ZONING BOARD OF APPEALS COMPREHENSIVE PERMIT PUBLIC HEARING MEMORANDUM

- FROM: Barney Heath, Director of Planning and Development Michael Gleba, Sr. Planner
- COPIED: Mayor Setti D. Warren Dan Violi, Chair, Newton Housing Partnership Councilors from Ward 5
- SUBJECT: Application #1-16, Waban AMA Realty Ventures LLC, applying to the Zoning Board of Appeals for a comprehensive permit pursuant to G.L. c. 40B, §20-23, as amended, to construct 48 rental units including 38 market rate units and 10 affordable units to be called "1521 Beacon Street" on land located at 1521 Beacon Street in Newton, MA, Ward 5, Section 53, Block 34, Lot 04, containing approximately 70,335 square feet of land area in a Single Residence 2 (SR2), Zoning District.

RE: 1521 Beacon Street

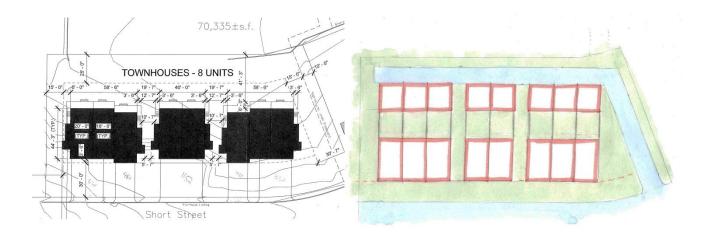
Where garages are set in front of the home and dominate the façade, they interfere with this relationship and diminish sense of community and safety. A prominent garage promotes a drive-in relationship with the neighborhood, rather than a personal connection."

With the passing of Ordinance #222-13, effective July 11<sup>th</sup>, 2016 all newly constructed residences with attached garages must meet the requirements of the new Section 3.4.4 (attached). The proposed site plan would be in violation of the new ordinance with respect to the following points:

- Where more than one garage is provided as part of a building and they are placed side-by-side, there shall be living area connected by a shared wall above both garages. (3.4.4.C)
- The length of a garage wall facing a street may be up to 40 percent of the total length of the building parallel to the street, inclusive of the garage wall, or 12 feet, whichever is greater. This requirement does not apply to detached garages. (3.4.4.E.1)

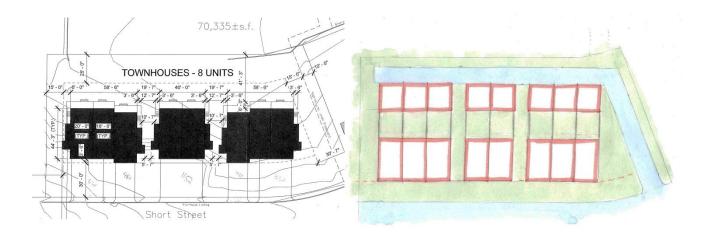
Where garages are set in front of the home and dominate the façade, they interfere with this relationship and diminish sense of community and safety. A prominent garage promotes a drive-in relationship with the neighborhood, rather than a personal connection."

With the passing of Ordinance #222-13, effective July 11<sup>th</sup>, 2016 all newly constructed residences with attached garages must meet the requirements of the new Section 3.4.4 (attached). The proposed site plan would be in violation of the new ordinance with respect to the following points:

- Where more than one garage is provided as part of a building and they are placed side-by-side, there shall be living area connected by a shared wall above both garages. (3.4.4.C)
- The length of a garage wall facing a street may be up to 40 percent of the total length of the building parallel to the street, inclusive of the garage wall, or 12 feet, whichever is greater. This requirement does not apply to detached garages. (3.4.4.E.1)
